UNITED STATES PATENT AND TRADEMARK OFFICE

APPLICATION NO.	FILING DATE	FIRST NAMED INVENTOR	ATTORNEY DOCKET NO.	CONFIRMATION NO.
10/705,273	11/10/2003	Brian J. Brown	S63.2N-6769-US03	4909
490	7590	08/19/2009	EXAMINER	
VIDAS, ARRETT & STEINKRAUS, P.A. SUITE 400, 6640 SHADY OAK ROAD EDEN PRAIRIE, MN 55344				BUI, VY Q
ART UNIT		PAPER NUMBER		
3773				
MAIL DATE		DELIVERY MODE		
08/19/2009		PAPER

Office Action Summary	Application No.	Applicant(s)	
	10/705,273	BROWN ET AL.	
	Examiner	Art Unit	
	Vy Q. Bui	3773

DETAILED ACTION

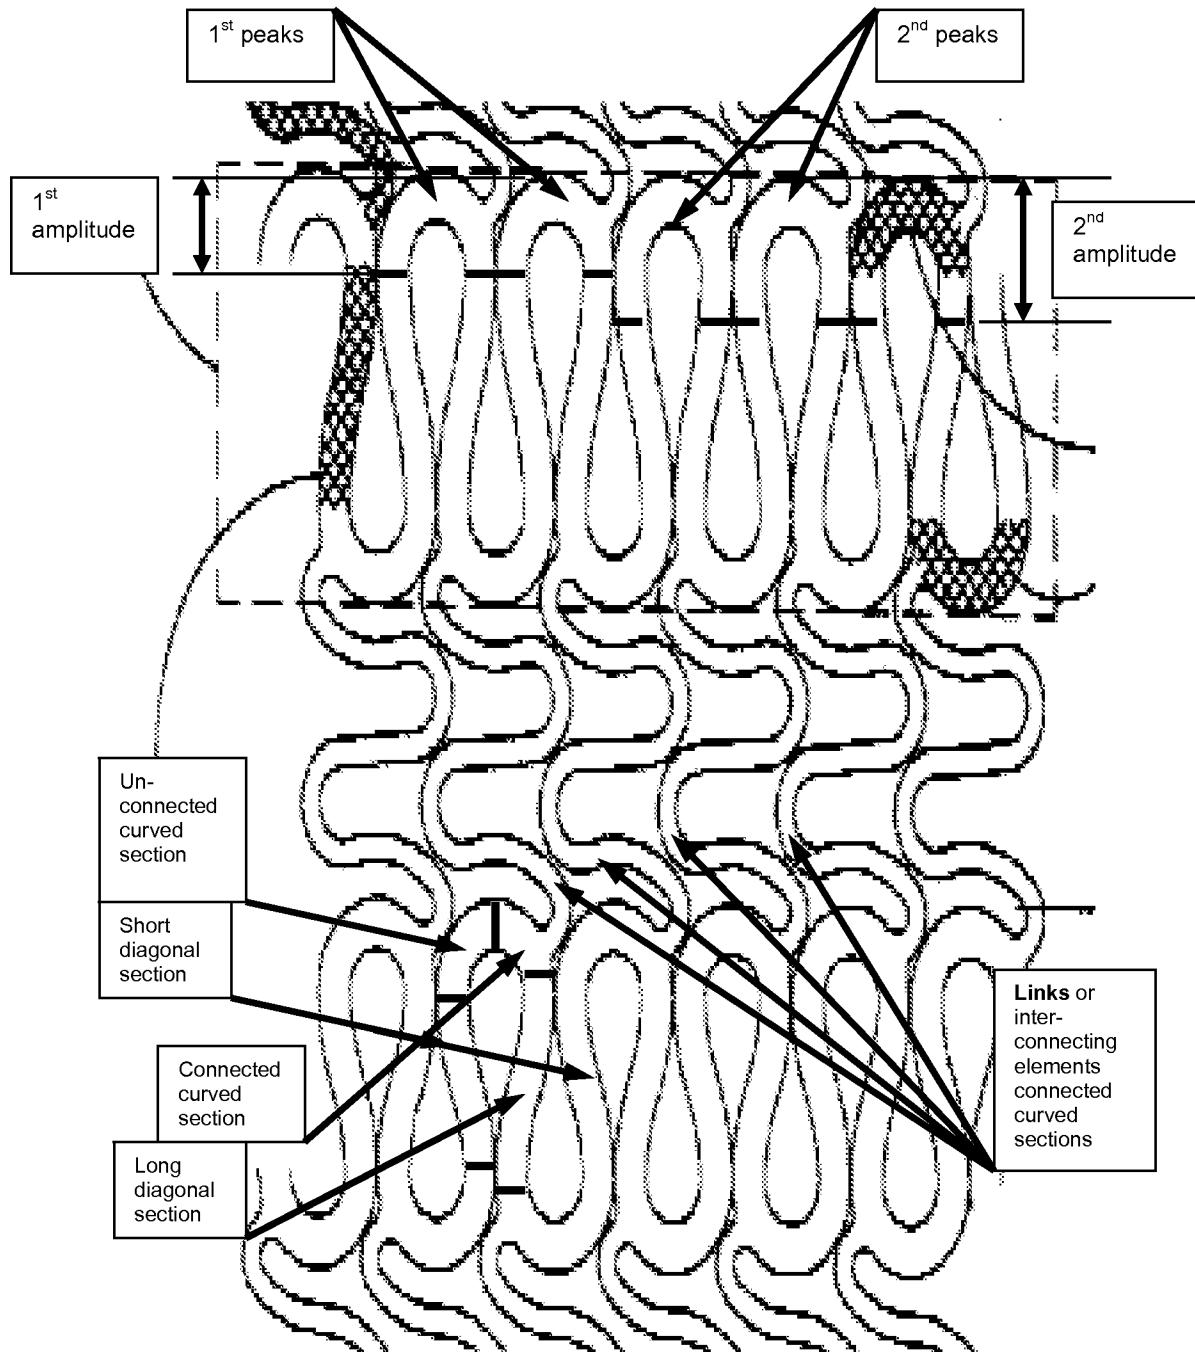
As to claims 38, 42-43, 45, 58-60 and 65, Fischell-'403 discloses a stent made of a stainless steel. Notice that the limitation "short diagonal section", "long diagonal section", "unconnected curved section", and "connected curved section" in the claims are broadly interpreted. Therefore, partial of Fischell-'403's Fig. 9 reproduced below shows each circumferential set of strut members including links 44 connecting "connected curved sections", short diagonal sections, long diagonal section, unconnected curved sections and connected curved sections to define connected strut members and unconnected strut members substantially as recited in the claims.

Notice that there is nothing in the claims to exclude the interpretation of Fischell-'403's Fig. 9 as presented below. The applicant is expected to amend the claims to distinguish the present claimed invention over Fischell-'403's.
